CUNARD EXPRESS STEAMER No. 735.

NOTES OF INTERVIEW WITH THE REPRESENTATIVES OF LLOYDS AND  
JOHN BROWN & COMPANY IN LONDON.

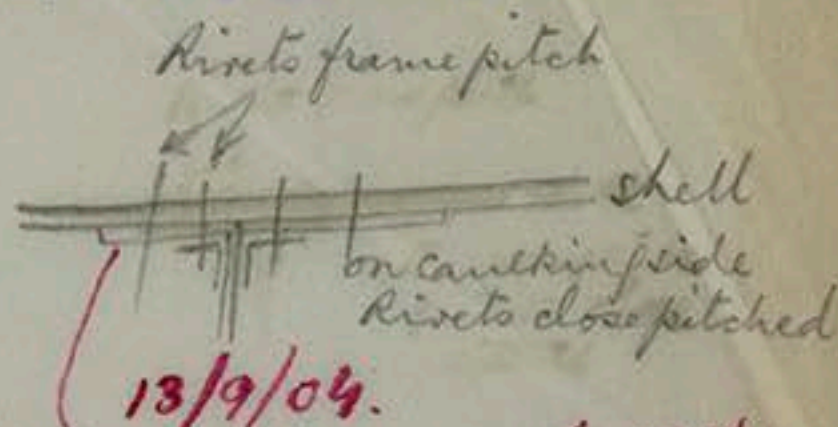
WATERTIGHT BULKHEADS.- Plating to lower deck of high tensile steel 10/20 to 9/20 equally divided, stiffening bars of mild steel Bulkheads above lower deck as previously agreed. The longitudinal bulkheads to be continuous, cutting ~~a~~ <sup>the</sup> athwartship bulkheads to be plated fore and aft, seams double rivetted, butts shifted.

The ground bar of the longitudinal bulkheads may be 5 x 5 x 12/20th or two double bars 4 x 4 x 12/20th (since reduced to 10/20) Top bar to be 5 x 5 x 10/20th. 4 bars connecting the longitudinal and athwartship bulkheads  $3\frac{1}{2}$  x  $3\frac{1}{2}$  x 10/20th. All  $\frac{1}{8}$ " Rivets to Lower deck. The ground bar of the athwartship bulkheads to be double, each 4 x 4 x 12/20th or If joggled  $4\frac{1}{2}$  x 4 by 12/20th (Since reduced to 10/20th).

#### FRAME FEET.-

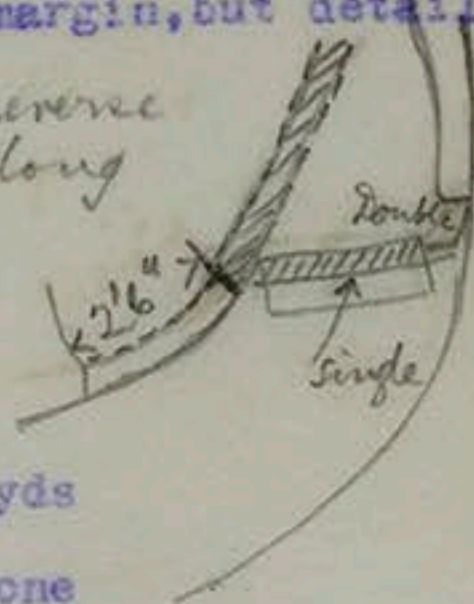
To be connected to tank top as per margin, but detail sketch to be submitted to Lloyds:- *either the reverse bar carried down 2-6 or a back bar 5 ft long 2-6 of which is to be carried down*  
 The SHELL within the double bottom to be painted.
